Appendix I of RNTPC
Paper No. A/YL-TYST/1276

**APPLICATION FOR PERMISSION
UNDER SECTION 16 OF
THE TOWN PLANNING ORDINANCE
(CAP. 131)**

(a) Proposed use(s)/development 擬議用途/發展	Proposed Temporary Warehouses for Storage of Electronic Goods and Construction Materials for a Period of 3 Years (Please illustrate the details of the proposal on a layout plan) (請用平面圖說明擬議詳情)

Government Departments' General Comments

Figure 2

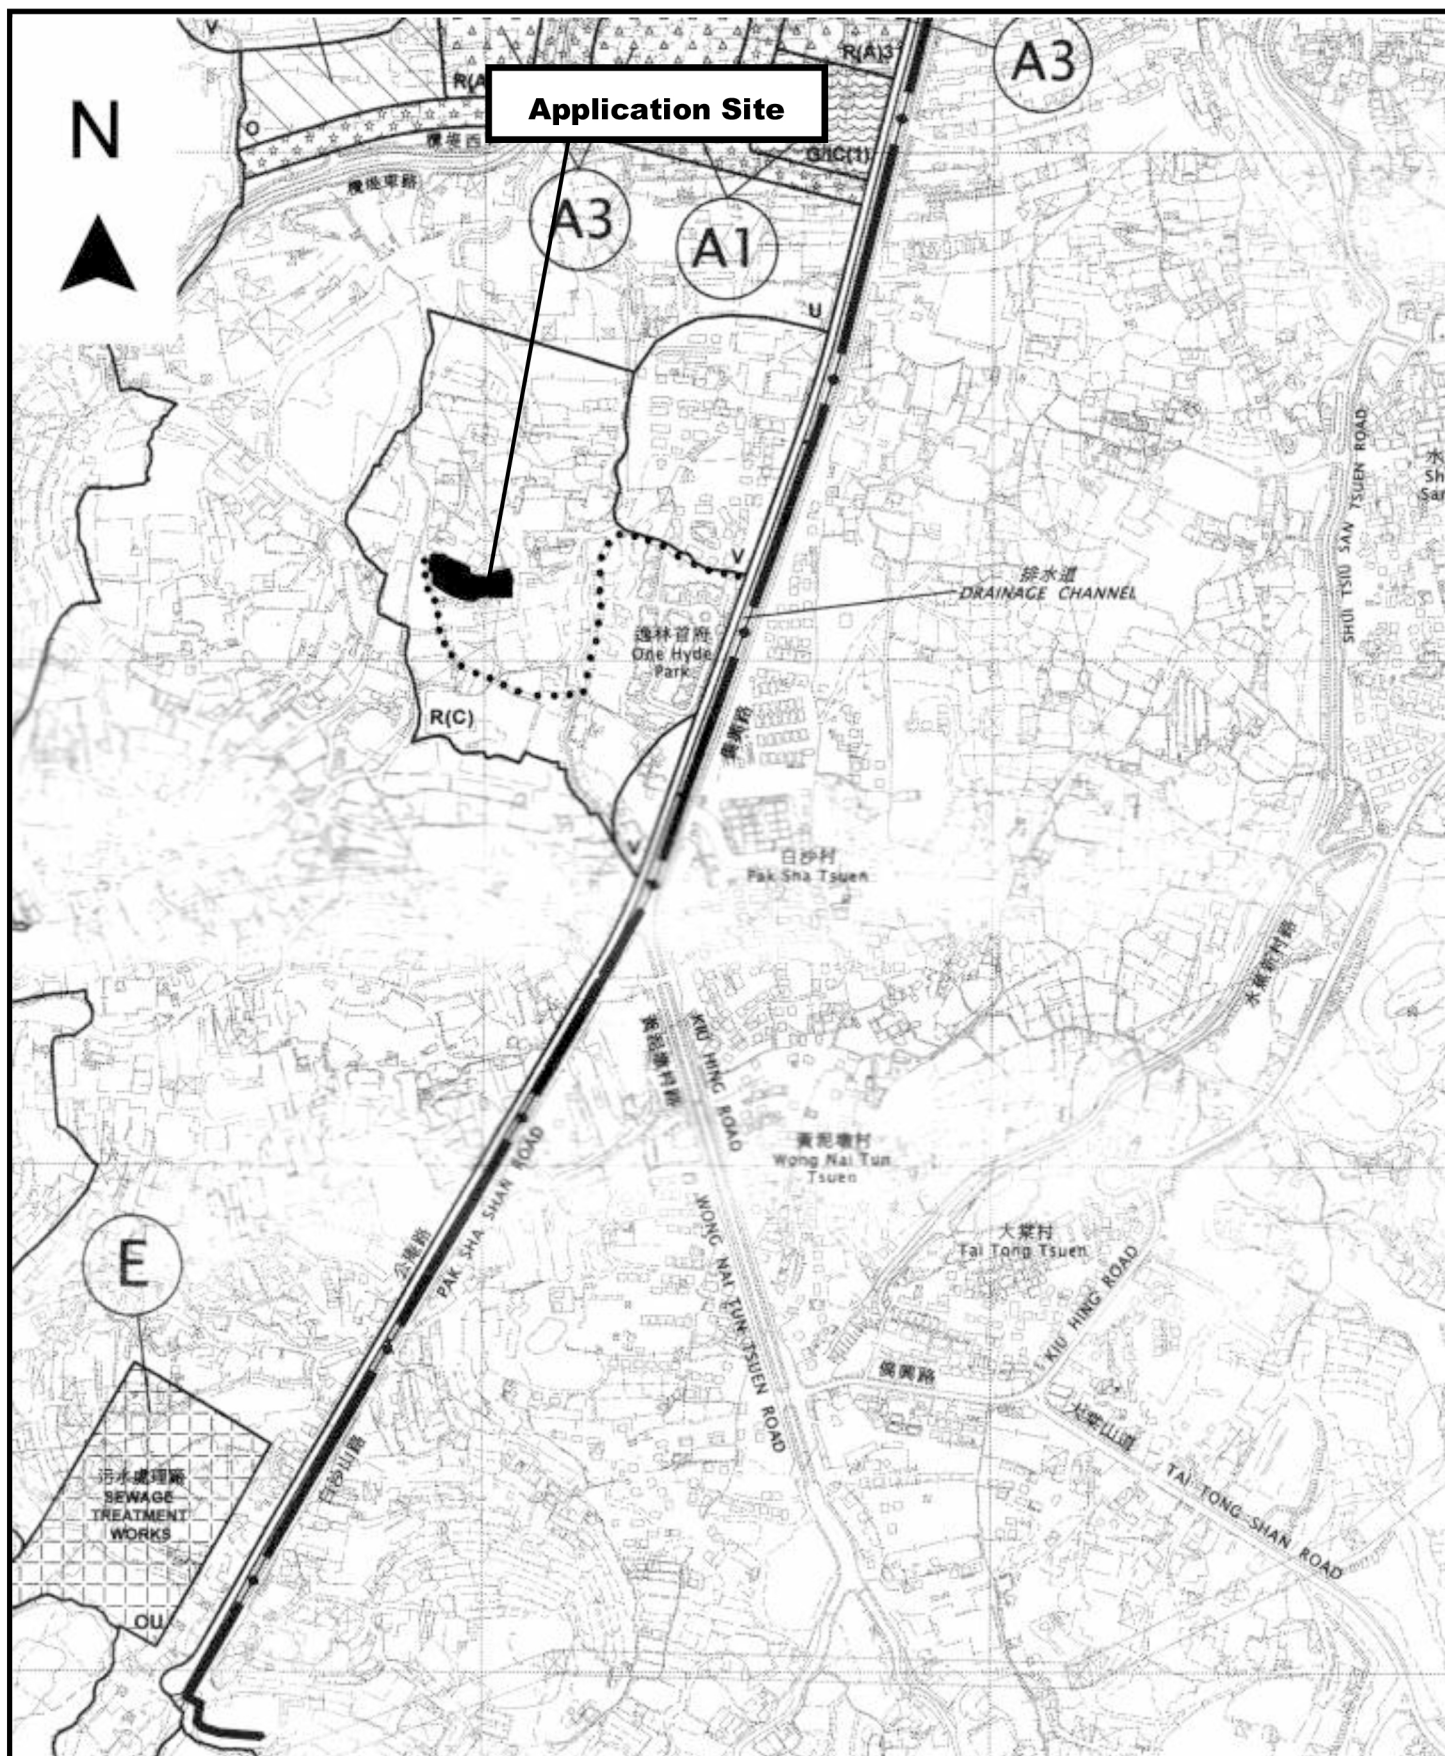
- no adverse comment on the application from traffic engineering perspective; and
- the local track and footpath leading to the application site (the Site) is not under her purview.

- (c) to note the comments of the Commissioner for Transport (C for T) that:
 - (i) consent of the owners/managing departments of the local track and footpath should be obtained for using it as the access to the Site; and

- (ii) sufficient manoeuvring space should be provided within the Site. No vehicles are allowed to queue back to public roads or reverse onto/from public roads;

- (ii) the access road connecting the Site with Kung Um Road is not and will not be maintained by his office. His office should not be responsible for maintaining any access connecting the Site with Kung Um Road;
